**MAINE TURNPIKE AUTHORITY**

**ADDENDUM NO. 2**

**CONTRACT 2018.17**

**AUBURN EXIT 75  
TOLL SYSTEM UPGRADES  
AND STREAM RELOCATION (MM 75.3)**

SHEET NUMBER: EQ-01

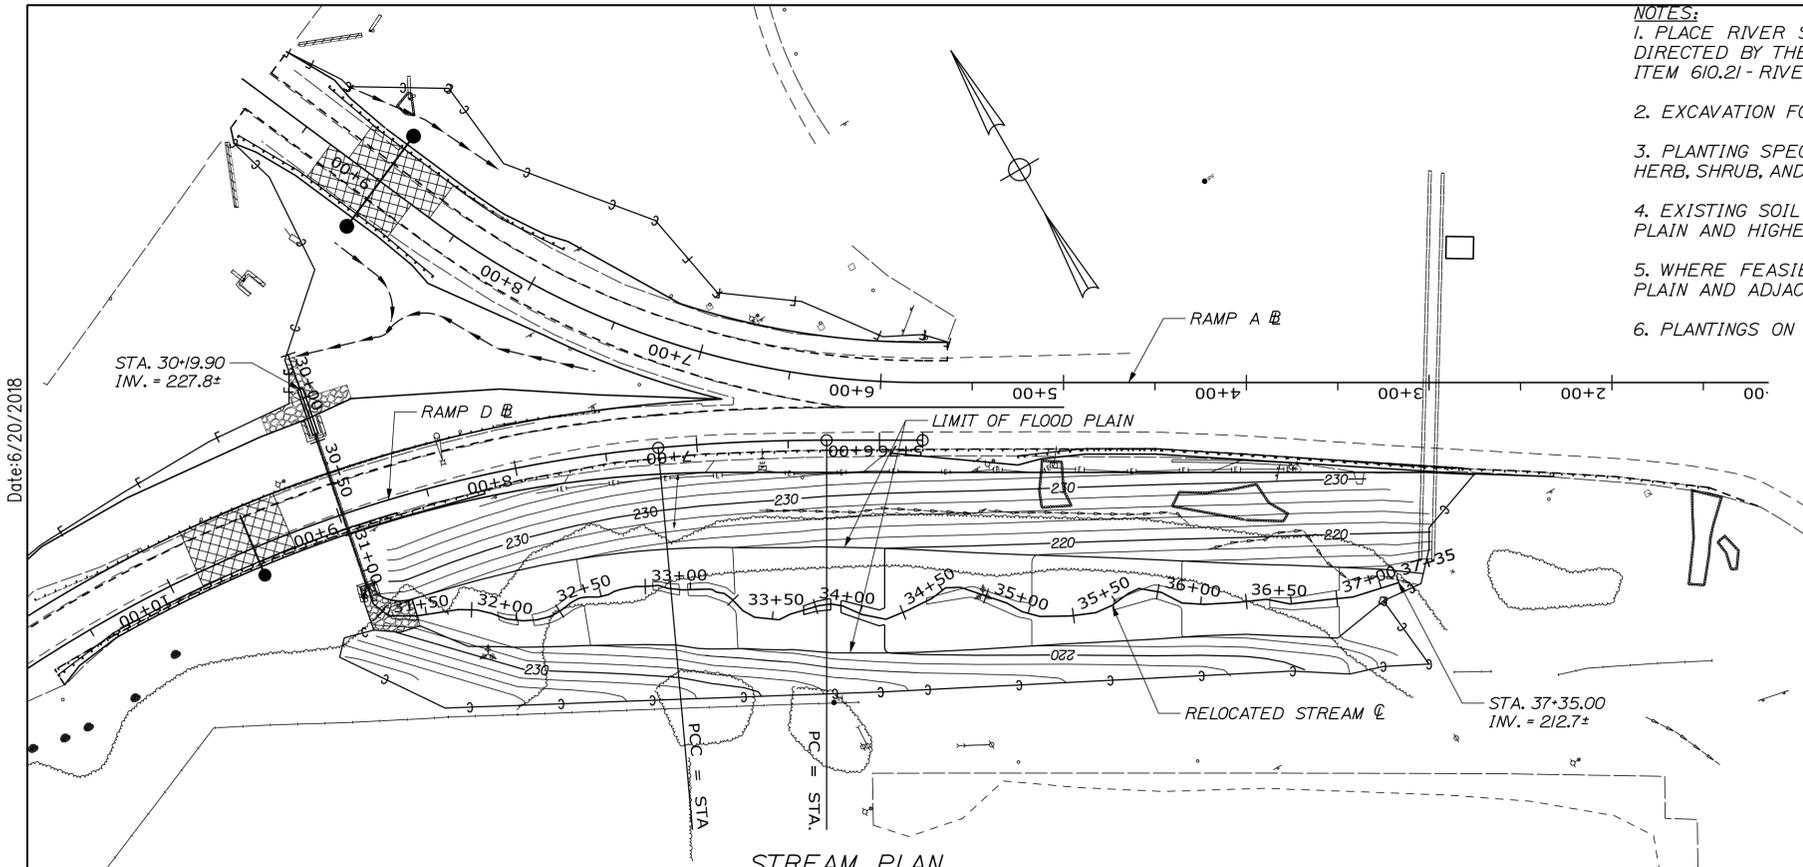
**Question 1:** On the Estimated Quantities sheet (2 of 84), the quantity of Item 652.41 for the Exit 75 work shows four (4 each) yet the bid quantity is one (1 each). Is the intent to provide 4 ea. PCMS for the duration of the work @ Exit 75?

**Answer:** No – See attached revised plan Sheet number EQ-01 (2 of 84).

Scale:			
No.	Revision	By	Date
1	UPDATED ITEM 625.41 QUANTITY	CDH	06/18

GENERATOR PAD DETAIL  
N.T.S.

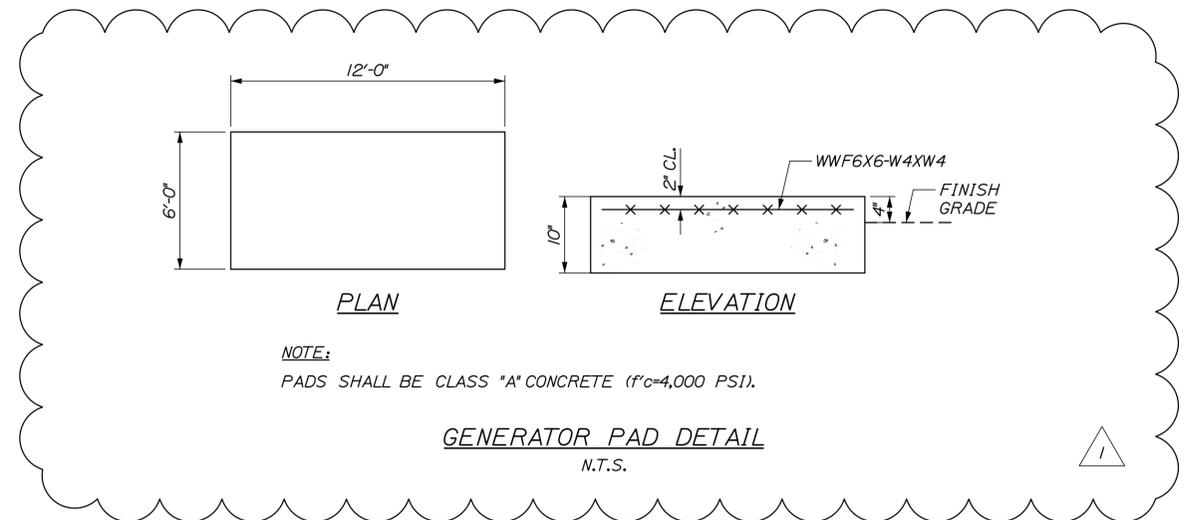
**Question 5:** Is there a detail for the generator pad?

**Answer:** See attached plan sheet number B-01(77 of 84).

No.	Revision	By	Date
1	ADDED GENERATOR PAD DETAIL	CDH	06/18
